PROJECT COMMENTS

DATE: 6/20/2025

PROJECT NUMBER: SP2025-023
PROJECT NAME: Site Plan for REC Campus Expansion Soccer Field & Parking
SITE ADDRESS/LOCATIONS: 2750 S GOLIAD ST, ROCKWALL, TX 75032

JOB NO. 3036-21	DESIGN BY JMJ
CREATED	CODE
PLOTTED 06/12/2025	CHECKED BY RDE
LAST UPDATE BY	
DRAWN: RDE	SCALE: AS NOTED
CHECKED:	DRAWING NO.: SP-1
APPROVED:	ISSUE: 0
FILENAME:

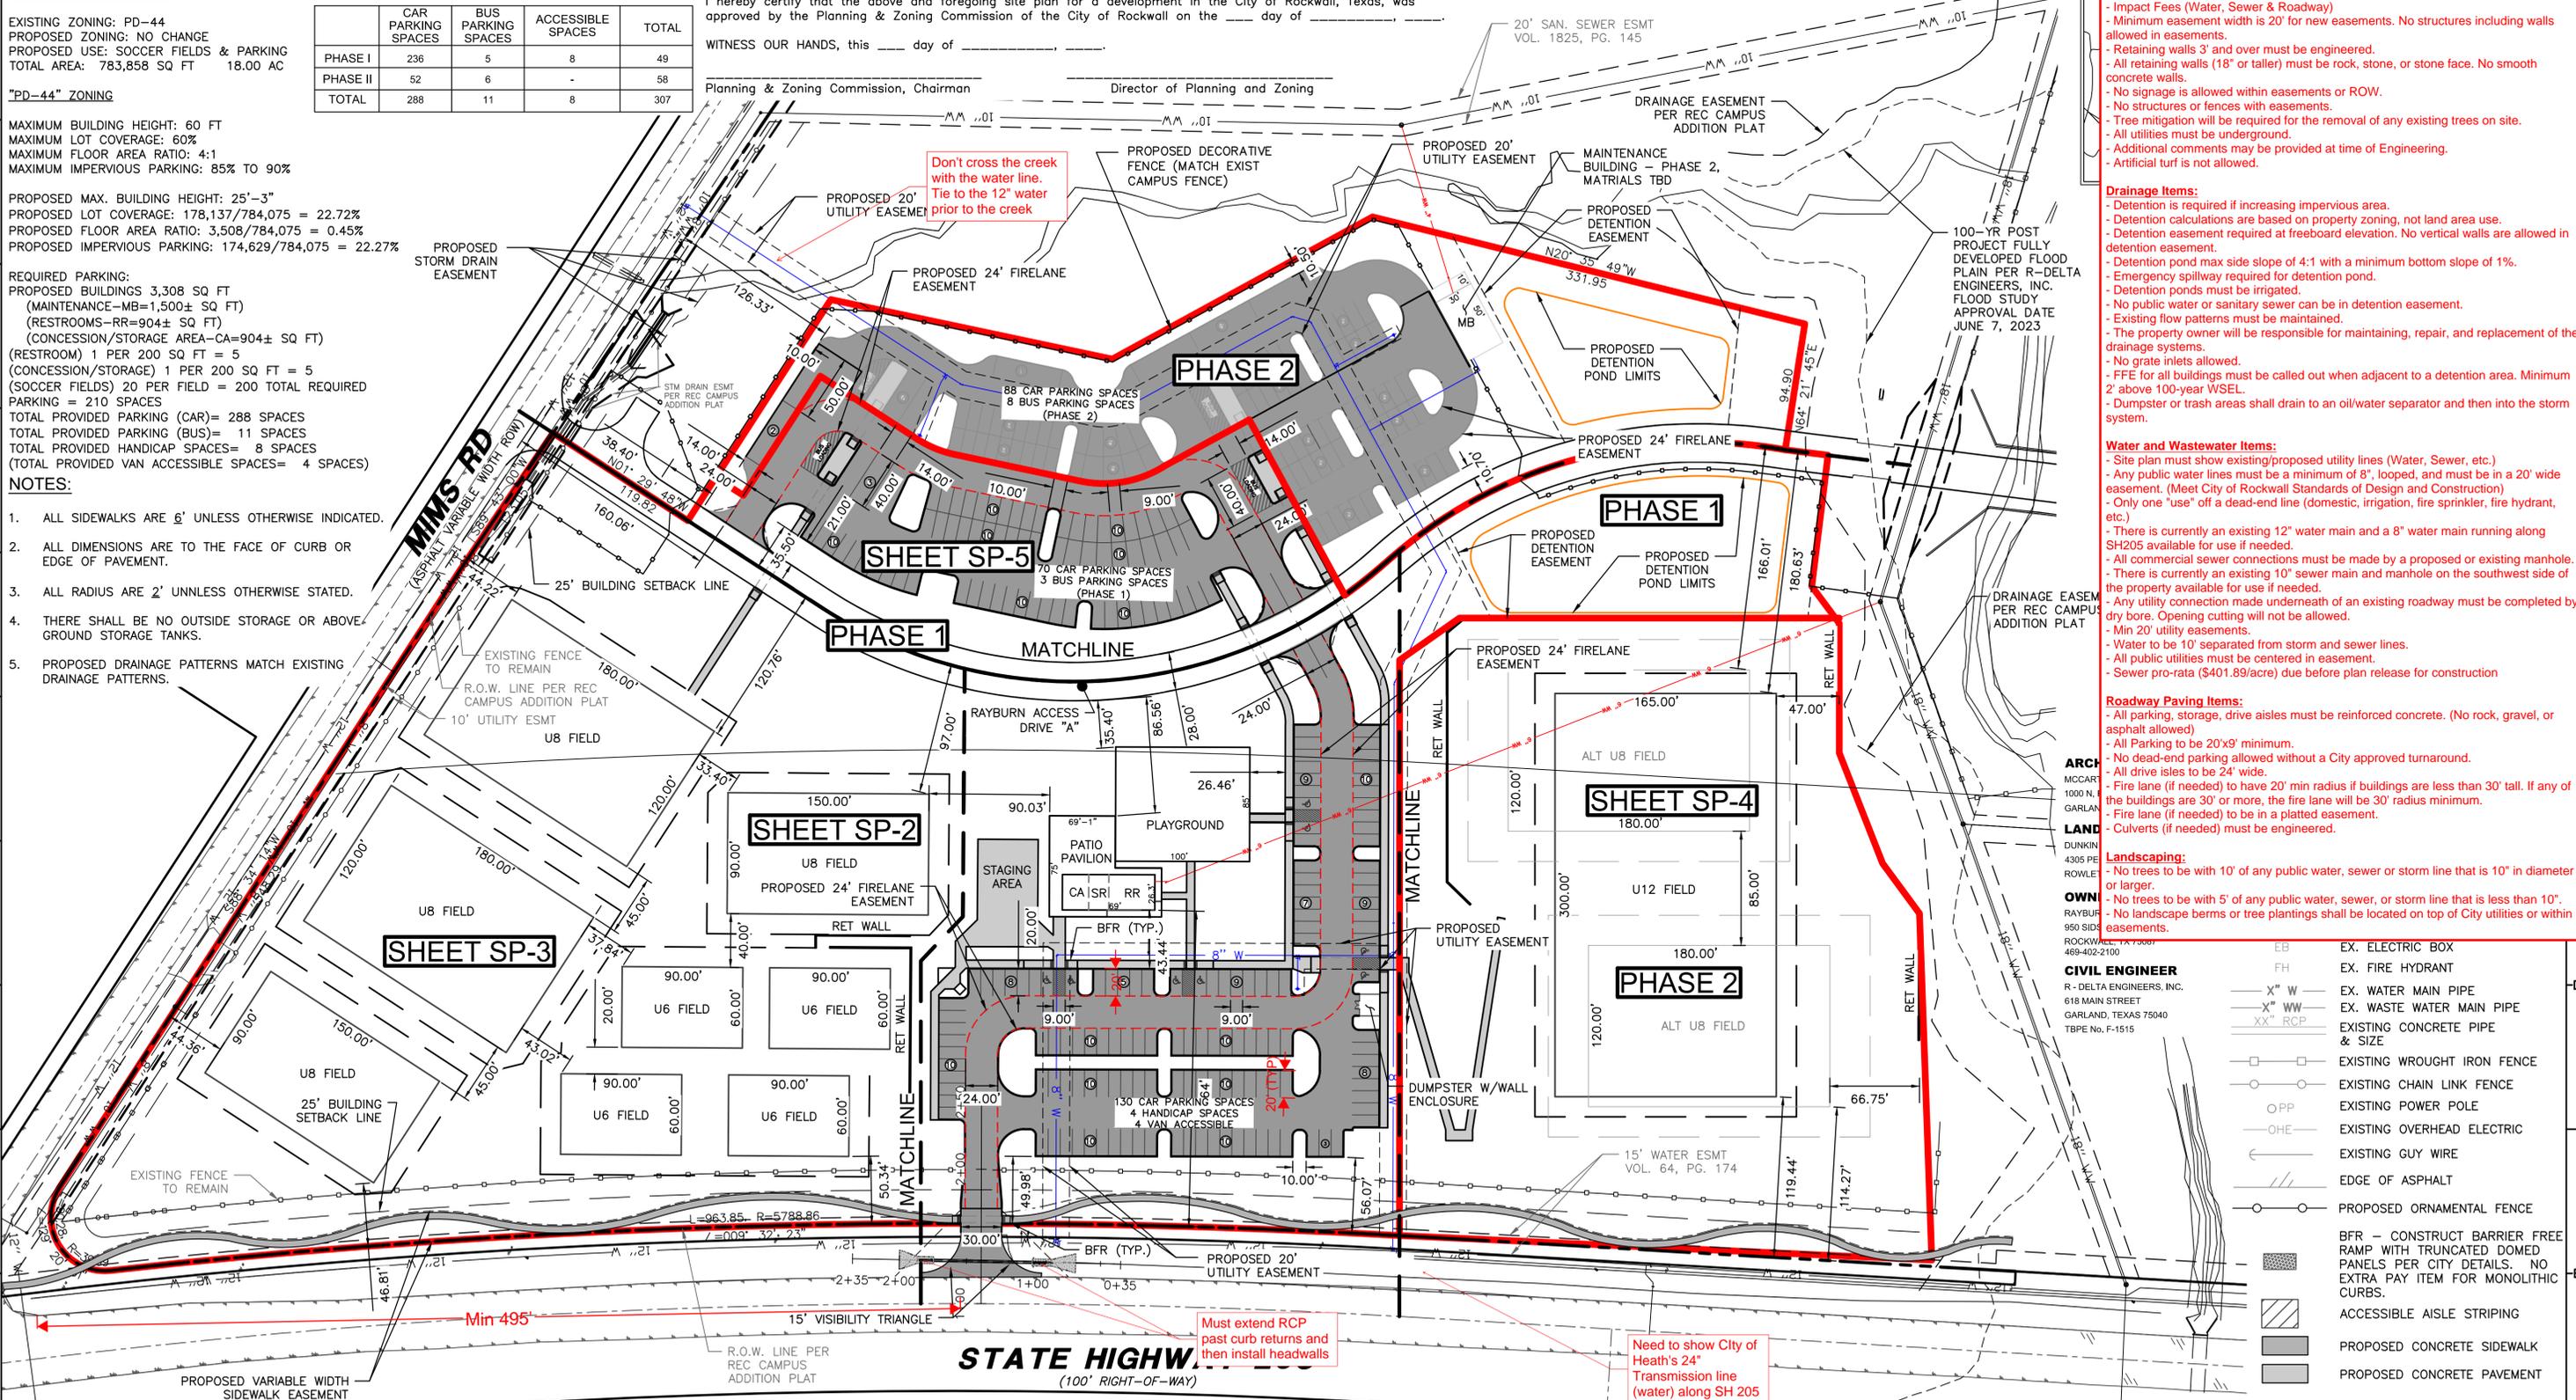
M.6 Site Plan.

(1) Please provide a schematic/detail of the proposed playground. (Subsection 03.04. B, of Article 11, UDC)

- (2) Please clarify what the staging area will be for. (Subsection 03.04. B, of Article 11, UDC)
- (3) Parking for the concession stand will be calculated at 1 per/100 SF for a total of ten (10) parking spaces. This brings the total required parking to 210. In addition, the parking table indicates that 248 parking spaces are being provided with Phase 1, however, only 213 are shown. (Subsection 03.04. B, of Article 11, UDC)

- (4) Signage is done through separate permits with the Building Inspections Department. (Subsection 06.02. F, of Article 05, UDC)
- (5) Please indicate any existing or proposed fencing. Please delineate the location and provide the material and height. (Subsection 08.02. F, of Article 08, UDC)

- (7) All pad mounted equipment must be shown on the site plan. This equipment must be screened with five (5) gallon evergreen shrubs, which should be shown on the landscape plan. (Subsection 01.05.C, of Article 05, UDC)

- (8) Please clarify if there will be any outside storage or above ground storage tanks. If so, it must be delineated on the site plan and property screened in accordance with Subsection 01.05, of Article 05, of the Unified Development Code (UDC). (Subsection 01.05, of Article 05, UDC)

- (9) Please provide a detail of the dumpster enclosure. In addition, the dumpster enclosure must be a minimum of eight (8) feet in height and use the same materials as the building. (Subsection 01.05. B, of Article 05, UDC)

TREE MITIGATION PLAN

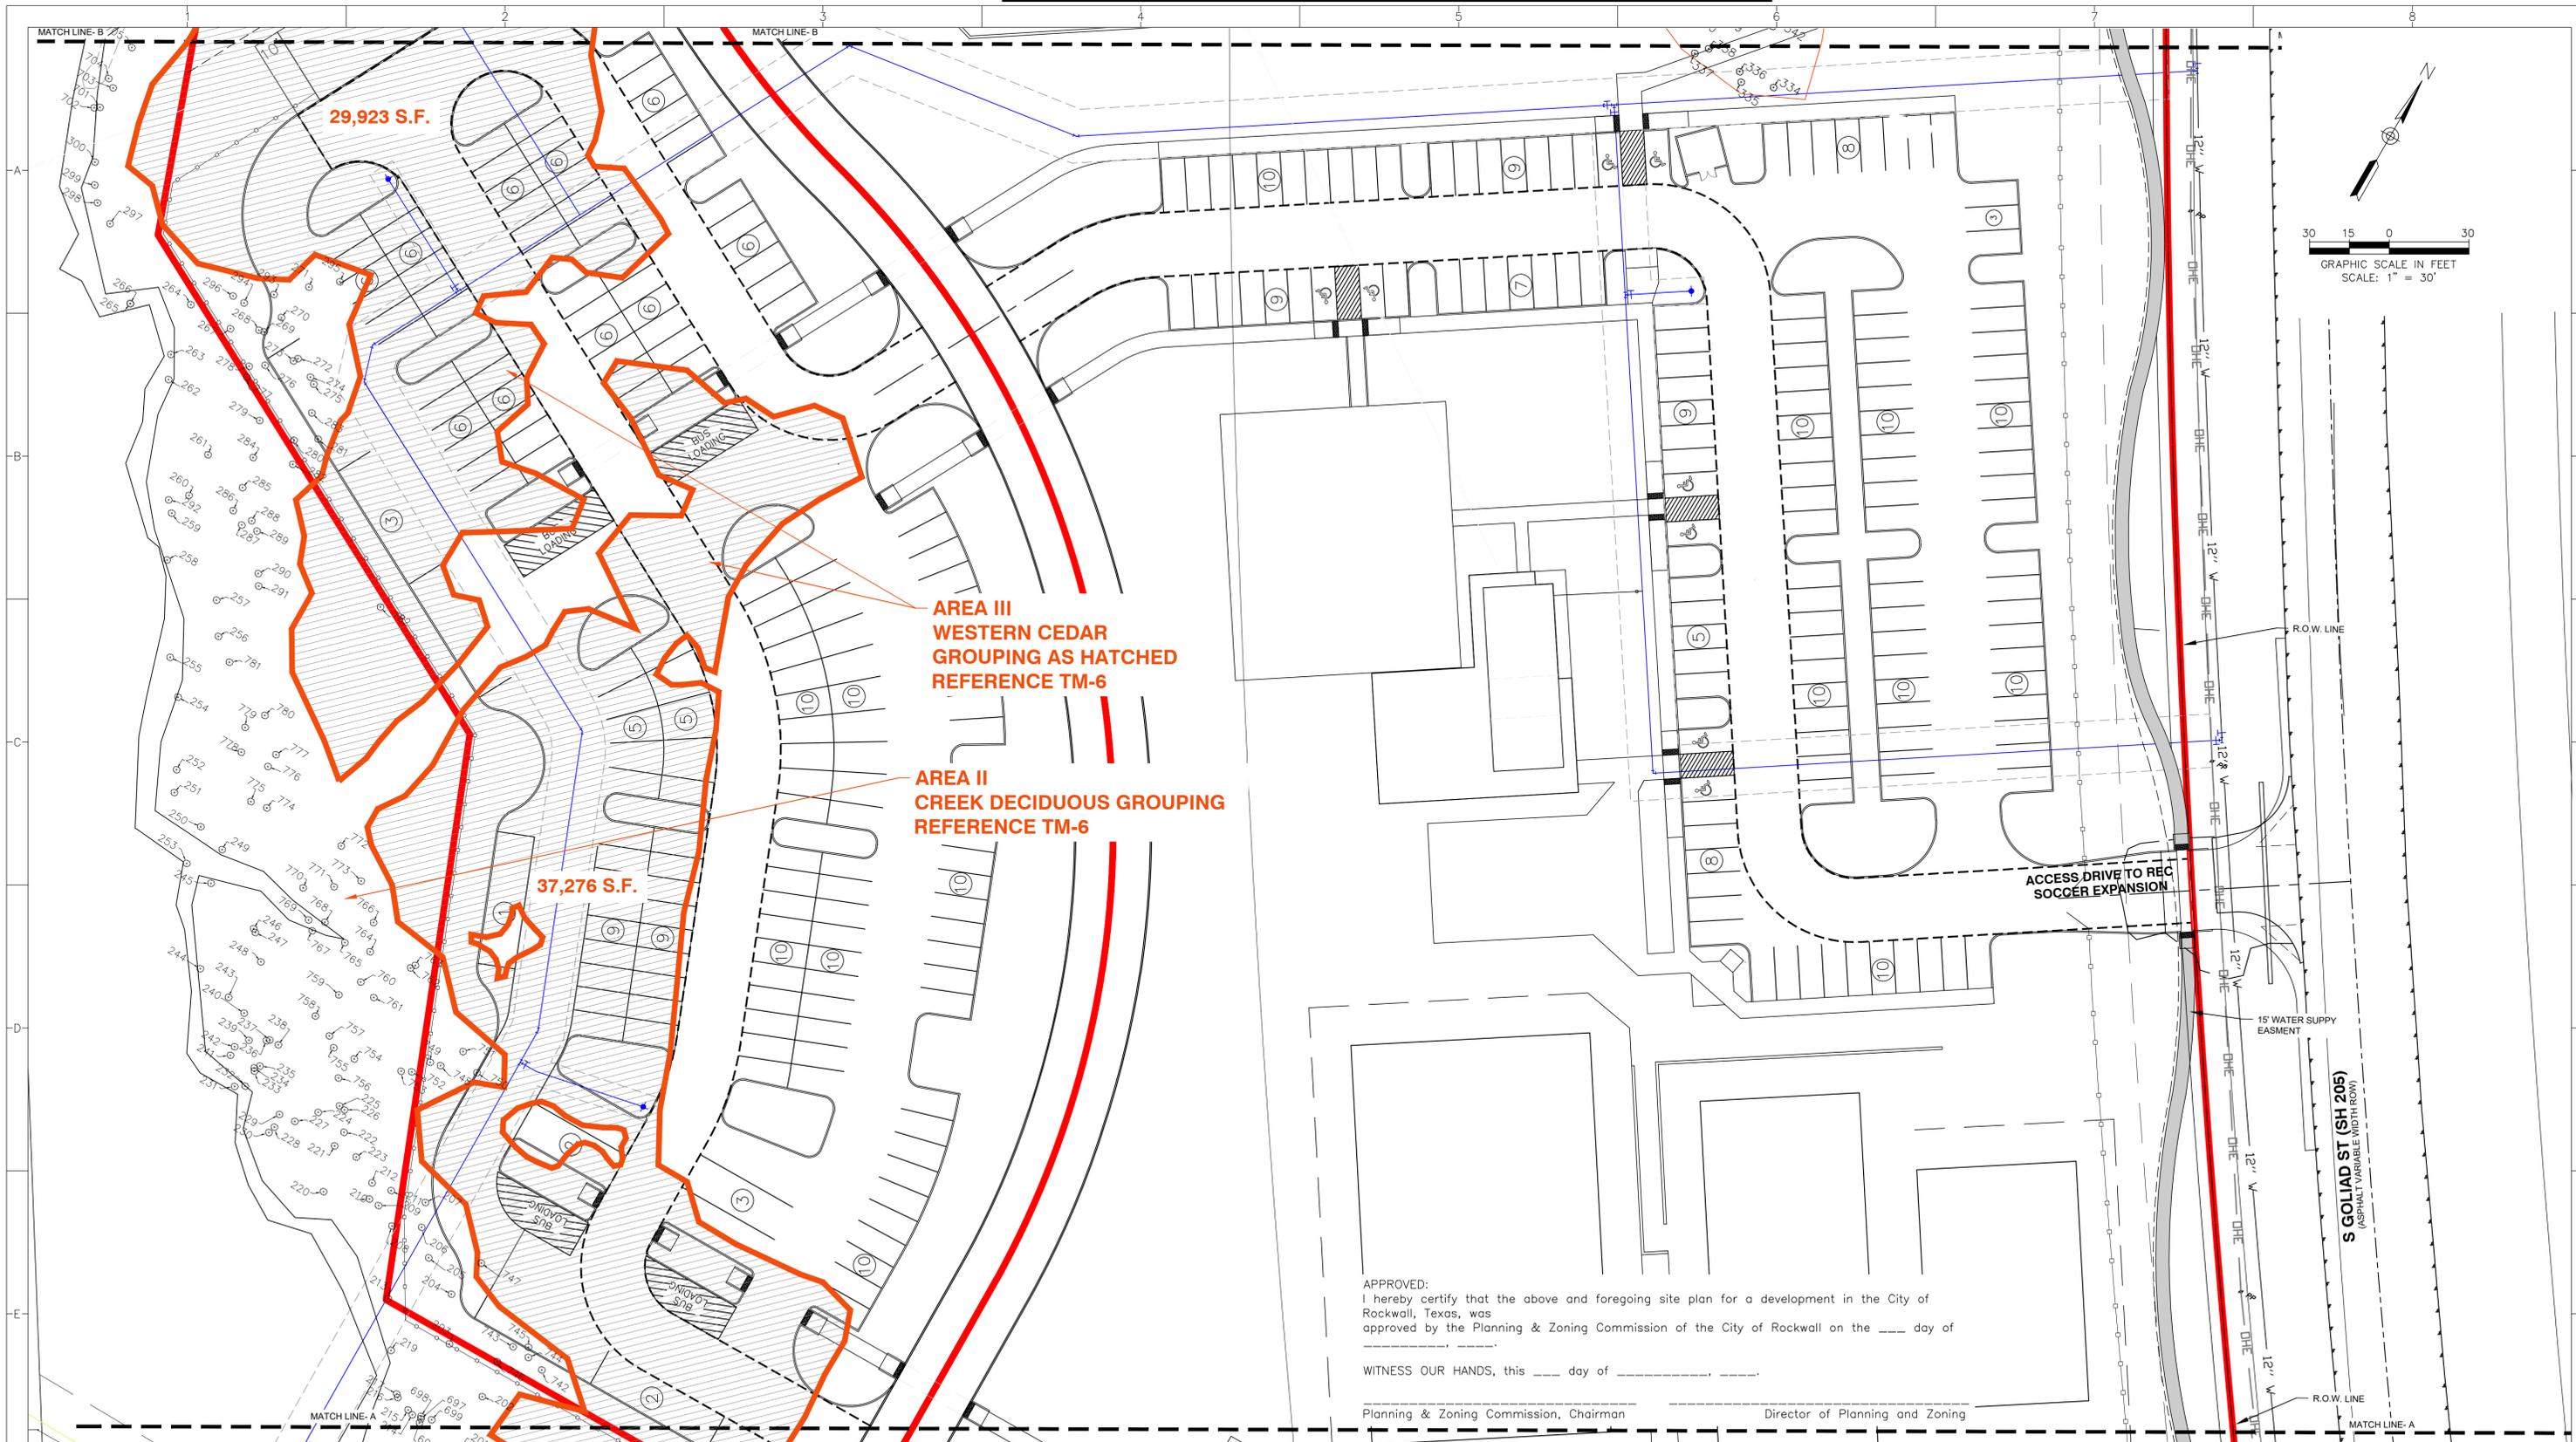
M.8 Treescap Plan

- (1) Provide the same site data information required in Section 2.1 Site Plan: Miscellaneous and Density and Dimensional Requirements of this checklist. (See Sec. 2.1 of the checklist)
- (2) The applicant is requesting an Alternative Tree Mitigation Settlement Agreement to (1) to allow the sample areas to be extrapolated and utilized to estimate the required mitigation, and (2) request that Eastern Red Cedar Trees not require mitigation. This brings the estimated mitigation to 99-caliper inches of trees. Based on the provided landscape plan, the estimated tree mitigation is satisfied. (Section 05, of Article 09, UDC)

06/17/2025: 1. Tree Mitigation (410 trees required what are plans for balance)

The mitigation waiver for removal of Cedar trees greater than 8-feet in height is requested due to the extremely large (876) number of Canopy Tree plantings that would be required per the current UDC. The previous UDC mitigation requirement for Cedar trees was limited to trees greater than 11-inches DBH. The 8-foot height threshold is a relatively recent (2024) addition to the Rockwall UDC. The project cannot support the expense of Cedar tree mitigation and will not move forward without this waiver.
